PLANNING REVIEW CHECKLIST

Subject Property: 1300 Block of Mildred Lane SE

Reference Nos.: 22-111298-ZO (Conditional Use)
22-111309-LD (Subdivision)
22-111312-ZO (Class 2 Adjustment)
22-111315-ZO (Class 2 Driveway Approach Permit)
22-111318-NR (Tree Conservation Plan)

TENTATIVE SUBDIVISION PLAN
DETAIL PLAN

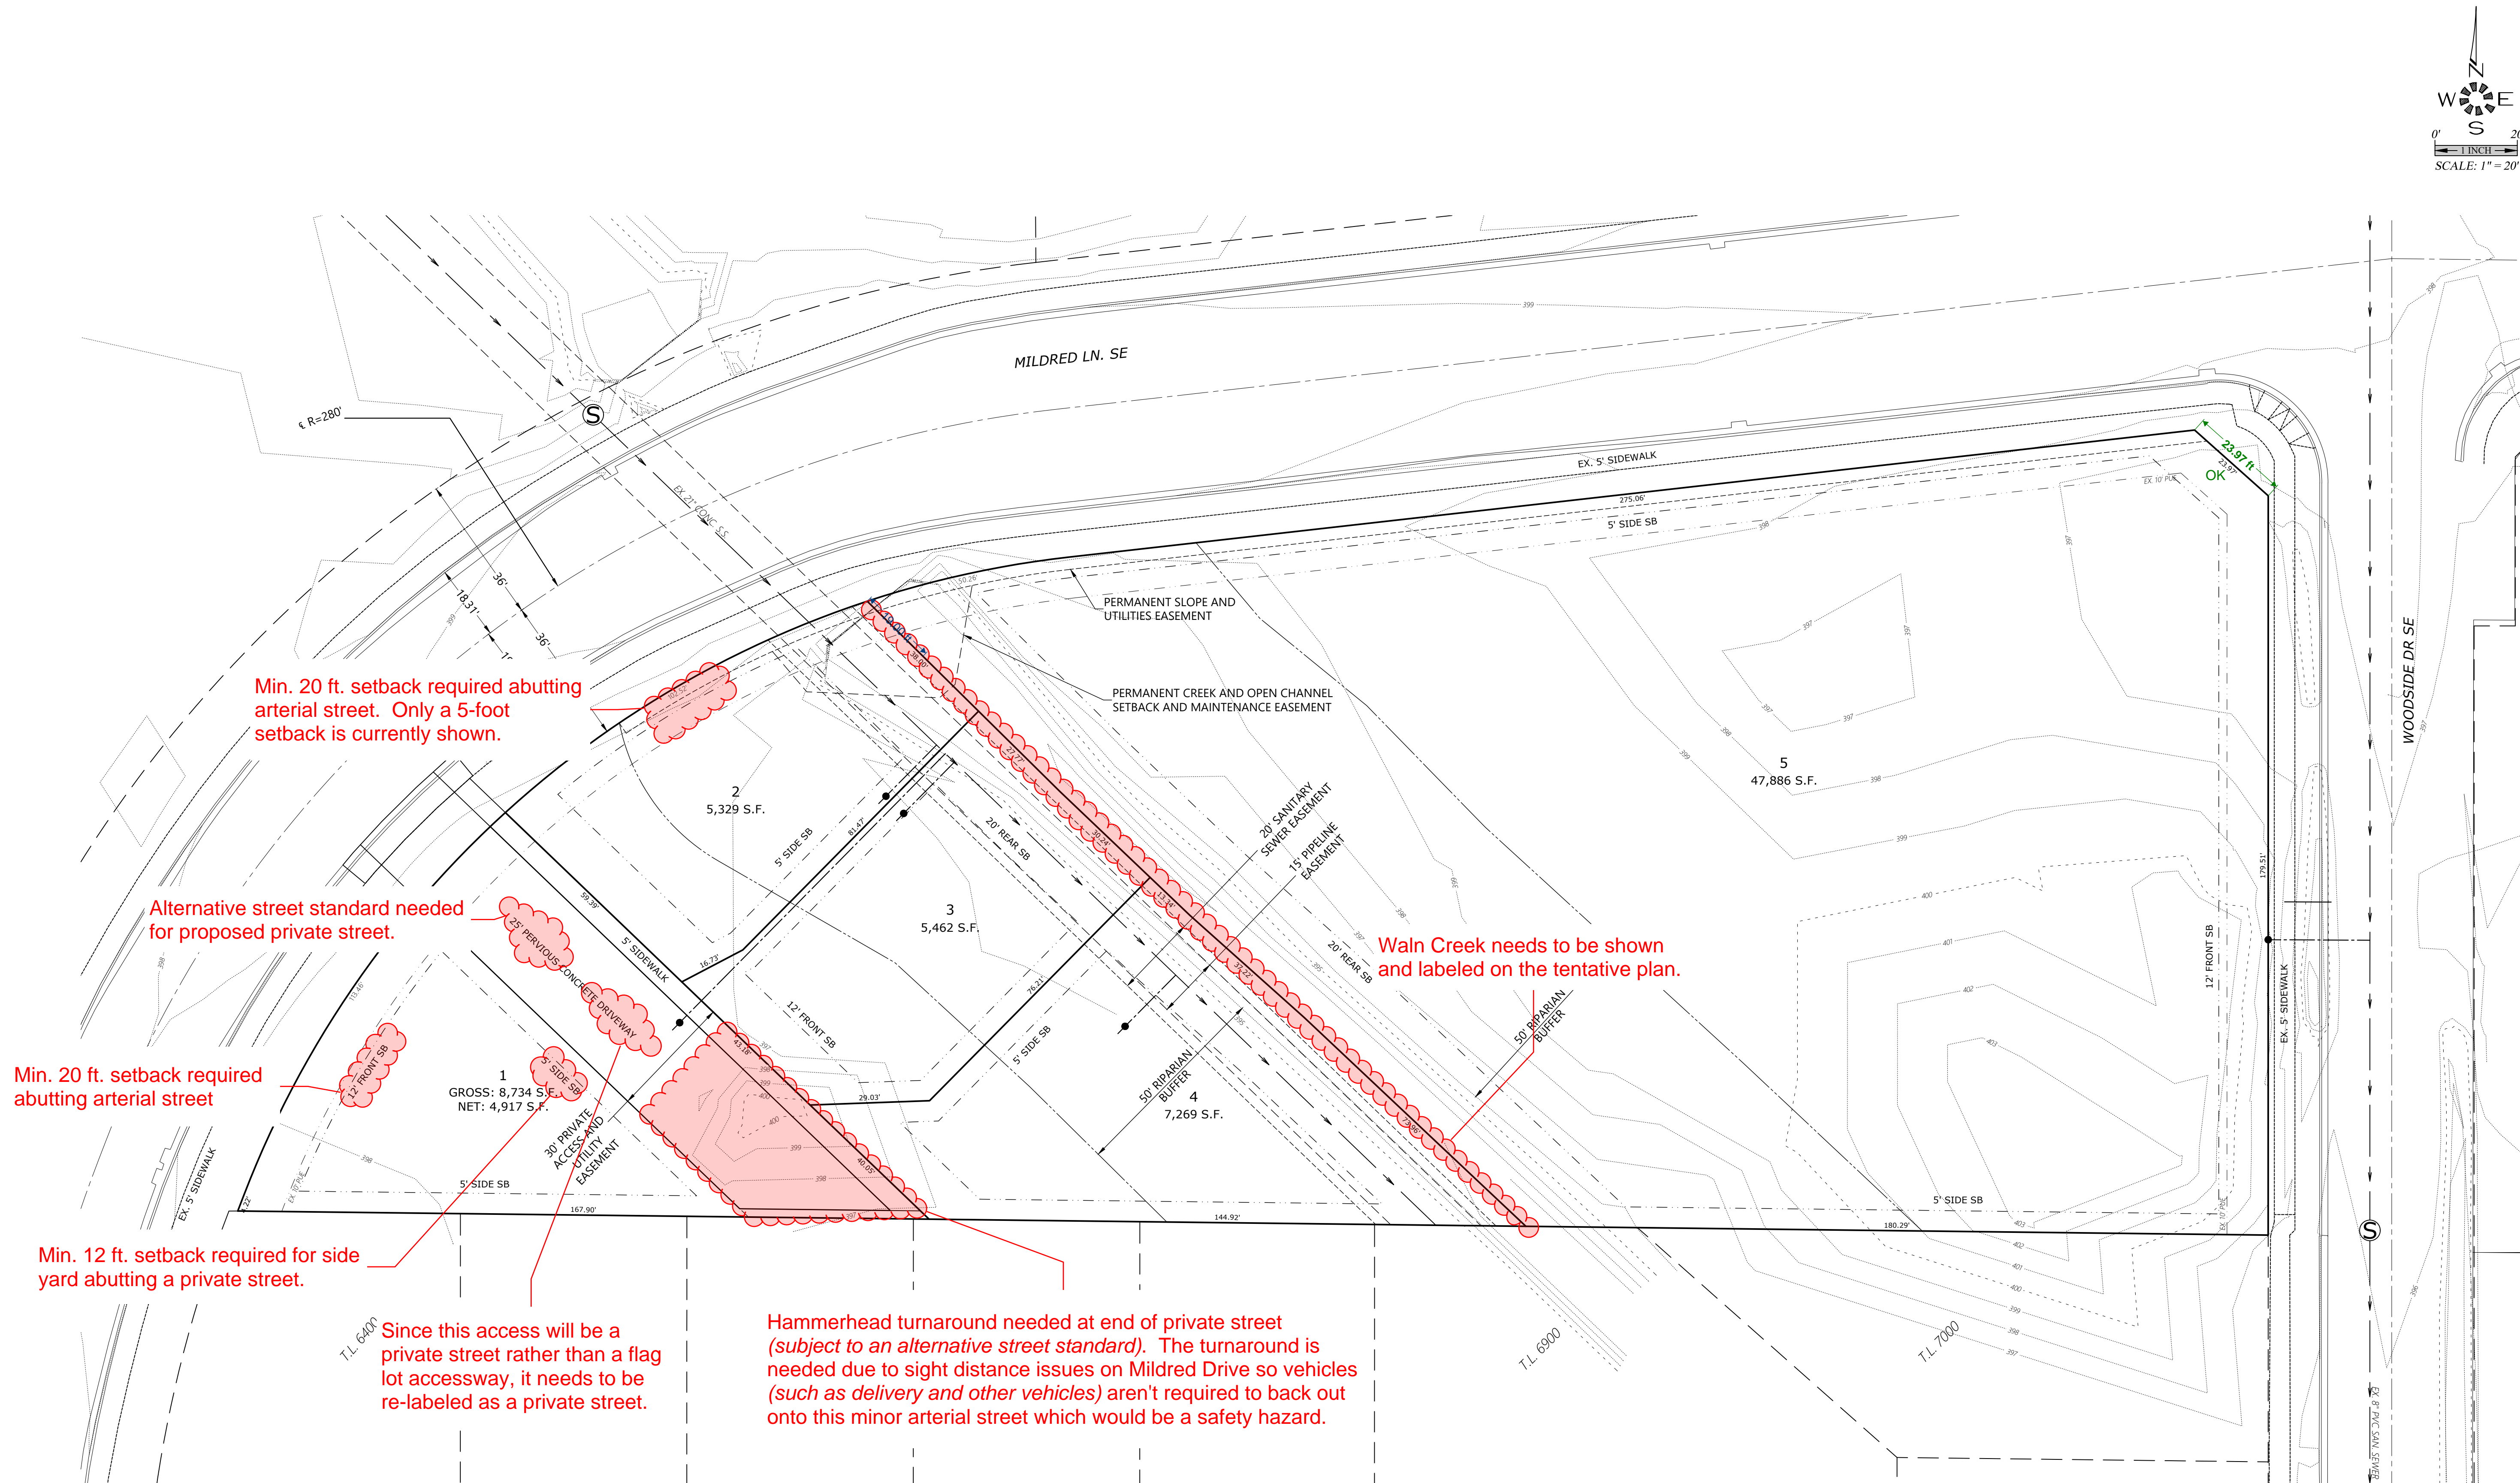
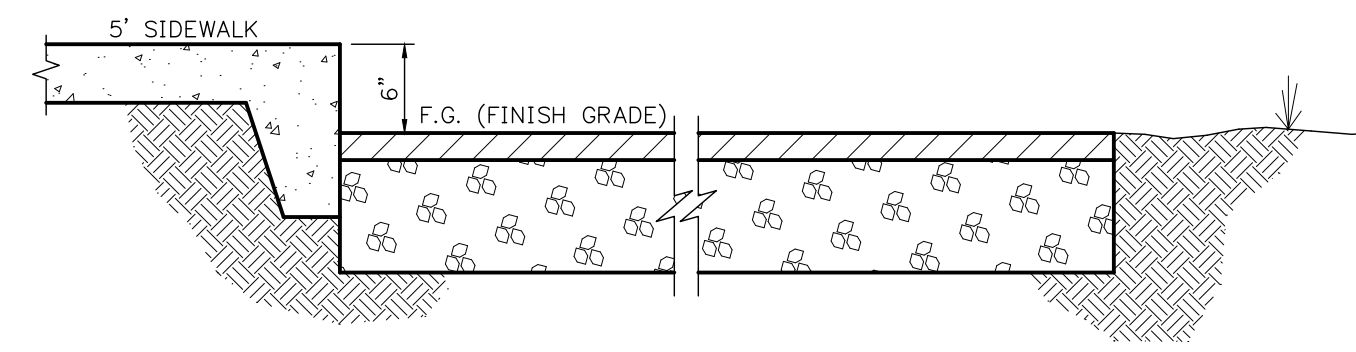
Min. 20 ft. setback required abutting arterial street. Only a 5-foot setback is currently shown.

Alternative street standard needed for proposed private street.

Min. 20 ft. setback required abutting arterial street

Min. 12 ft. setback required for side yard abutting a private street.

Since this access will be a private street rather than a flag lot accessway, it needs to be re-labeled as a private street.

Hammerhead turnaround needed at end of private street (subject to an alternative street standard). The turnaround is needed due to sight distance issues on Mildred Drive so vehicles (such as delivery and other vehicles) aren't required to back out onto this minor arterial street which would be a safety hazard.

Wain Creek needs to be shown and labeled on the tentative plan.
